# **Recall Campaign Bulletin**

Campaign No. 2024040007, April 2024

SUBJECT: Model E-Class (214 platform)

**Check Transmission Wiring Harness Routing**

Figure 1 - Red (A): Power supply line Green (B): Signal wires

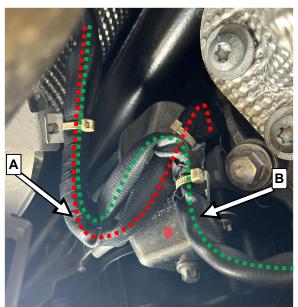
- 1. Check routing (**Figure 1**) and distance (**Figure 2**) between electrical wiring harnesses and the <u>transmission tunnel/drive</u> <u>shaft</u> and the <u>transfer case to front axle differential</u> (indicated parts).
  - It is **not necessary** to remove the rear underfloor paneling to check the routing.
  - The electrical wiring harnesses *must not* be in contact with the transfer case to front axle differential.
  - Li The distance between the electrical wiring harness and the drive shaft *must be* at least 10 *mm* (Figure 2, A).

- a. Electrical wiring harness is in contact with indicated parts but is not damaged: Carry out Work Procedure 1.
- b. Electrical wiring harness is in contact with indicated parts and is damaged: Carry out Work Procedure 2:
   Work Procedure 2a: Only protective sheathing is damaged.
   Work Procedure 2b: Signal lines (Figure 1, B) are damaged.
- Electrical power supply line (Figure 1, A) (line cross-section 10 mm²) is damaged: Carry out Work Procedure 3.
- d. Electrical wiring harness is *routed correctly*: End Measure.

Figure 4

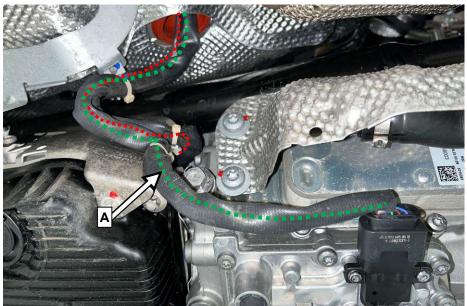
- Li Electrical wiring harness is in contact with indicated parts and *is damaged* (chafing, melting, tears/scoring).
- $oxed{1}$  If only the protective sheathing is damaged, and the electrical harness wiring has no signs of damage:
- 1. Wrap affected area with fabric tape.
- 2. Route electrical wiring harness (Figure 4, A) correctly as shown
  - The electrical wiring harness (Figure 4, A) must not be in contact with indicated parts in any location.

One or more of the electrical signal lines (line cross section 0.35 mm² to 0.75 mm²) in the electrical wiring harness (Figure 4, A) shows signs of damage.

- 1. Remove rear section of underfloor paneling.
  - i For basic information, see AR61.30-P-1001WT.
- 2. Repair the respective affected electrical signal line (line cross section 0.35 mm² to 0.75 mm²) in the electrical wiring harness (Figure 4, A) using a line connector.
  - i For basic information, see AR00.19-P-0100A.
  - To do this, cut the protective sheathing, repair wire harness using a line connector, and reinstall the protective sheathing using fabric tape to connect the cut sides.
- 3. Route electrical wiring harness (Figure 4, A) correctly as shown.
  - The electrical wiring harness (Figure 4, A) must not be in contact with indicated parts in any location.
- 4. Assemble in reverse order.

Figure 5

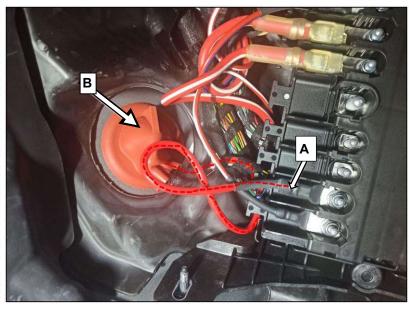
if the electrical power supply line (Figure 5, A) (line cross section 10 mm²) is damaged, replace electrical power supply line (Figure 5, A):

- Disconnect ground line of 12 V on-board electrical system battery.
   For basic information, see AR54.10-P-0051WT.
- Remove rear section of underfloor paneling.
   For basic information, see AR61.30-P-1001WT.
- 3. Remove protective metal sheet (Figure 6, A).
- **4.** Disconnect electrical power supply line (**Figure 5**, **A**) from electrical connector at transmission.
- Remove front floor covering at front passenger side.
   For basic information, see AR68.80-P-0008WT.
- **6.** Remove electrical power supply line (**Figure 5, A**) with grommet (**Figure 5, B**).
- Replace electrical power supply line (Figure 5, A).
   The electrical wiring harness must not be in contact with indicated parts at any location.
- 8. Assemble in reverse order.
